Item ID: D5162-041 Accept ***N900040100*** Setup Start ***NS1***
Revision ID: Stop ***NS2***
Item Name: Seat Structure Assembly
Start Date: 9/19/2016 Start Qty: 1.00 ***1*** Cust Item ID:
Required Date: 9/26/2016 Req'd Qty: 1.00 ***1*** Customer:
Reference:

DRAWING NO. D3016	TITLE SEAT FRAME ASSEMBLY	REV. A	DART AEROSPACE LTD ENGINEERING ORDER	D.E.O. NO. D3016-A-1	SHEET NO. SHEET 1 OF 1	SCALE NTS
DRAWN <i>1</i>	CHECKED <i>JP</i>	MFG. APPR. <i>RE</i>	APPROVED <i>WAP</i>	DE APPR. <i>WAP</i>		
DATE 10.01.29	DATE 10.01.29	DATE 10.01.29	DATE 10.01.29	DATE 10.01.29	DATE 10.01.29

D3016-11 SADDLE

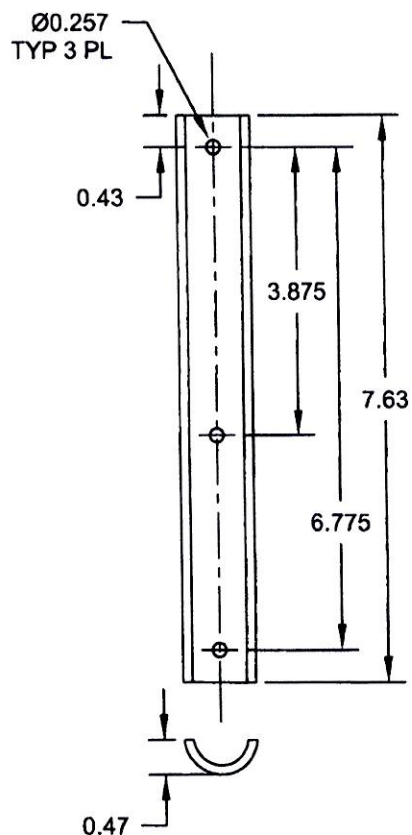
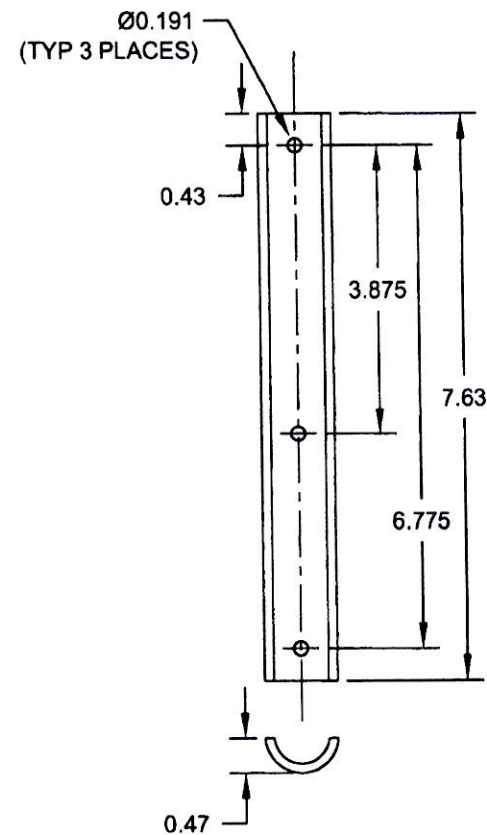
TO REVISE D3016-11 SADDLE'S HOLE SIZES

DETAIL D3016-11 SADDLE (SHEET 3): Ø0.257 TYP 3 PL WAS Ø0.191 (TYP 3 PLACES) AS SHOWN:
